**HISTORIC PRESERVATION REVIEW BOARD  
STAFF REPORT AND RECOMMENDATION**

Landmark/District:	<b>Georgetown Historic District</b>	(x) Agenda
Address:	<b>1023, 1025 and 1027 31<sup>st</sup> Street NW</b>	
Meeting Date:	<b>September 22, 2022</b>	(x) Subdivision
Case Number:	<b>22-269</b>	(x) Alteration/addition (x) Concept

*Project area and context*

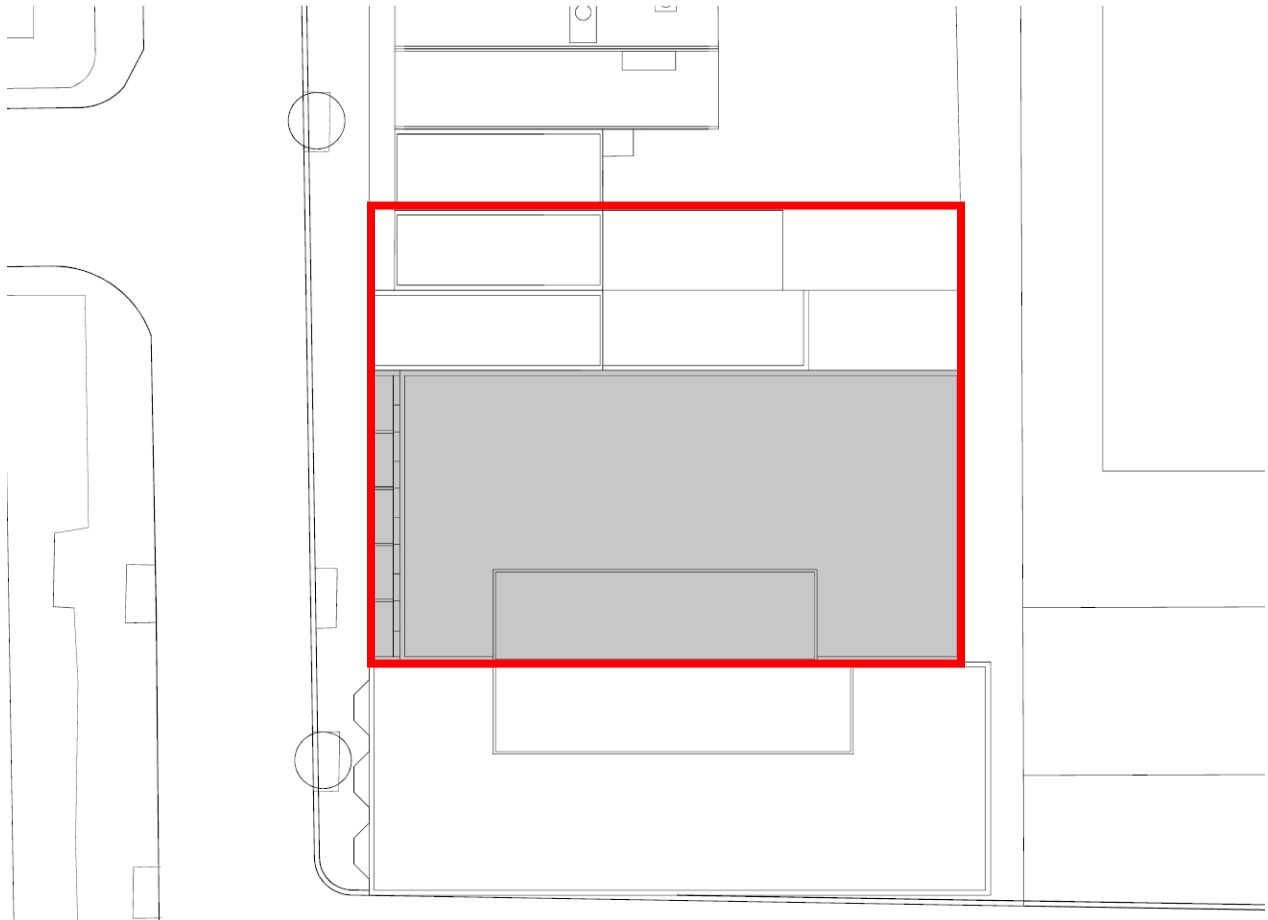
The project would incorporate two abutting two-story brick buildings to the north; 1027 31<sup>st</sup> dates to 1907 and 1027 is part of a 1907 row. These were originally homes but have been in commercial in recent years. They would contain ancillary uses, but their principal purpose in the concept is to provide the rear-yard space for the five-story addition. To provide both the addition and the court separating it from these modest buildings, rear wings would be demolished. That at 1027 31<sup>st</sup> appears to be the original, one-story kitchen encapsulated within a later, commercial

addition. All the additions at both buildings date to the 1980s or later, the most recent being an unpermitted sunroom addition erected in 2015 (there is an aerial photo and a photo of the rear of the buildings on the page 4 of this report).

That proposed demolition constitutes a distinct minority of the historic fabric and is consistent with the magnitude of demolition the Board has supported on similar projects. The question of what remains on the interiors remains important. The applicant has committed to retaining the floor assemblies, which do not align building to building. In permit review, staff can ensure that further demolition is minimized.
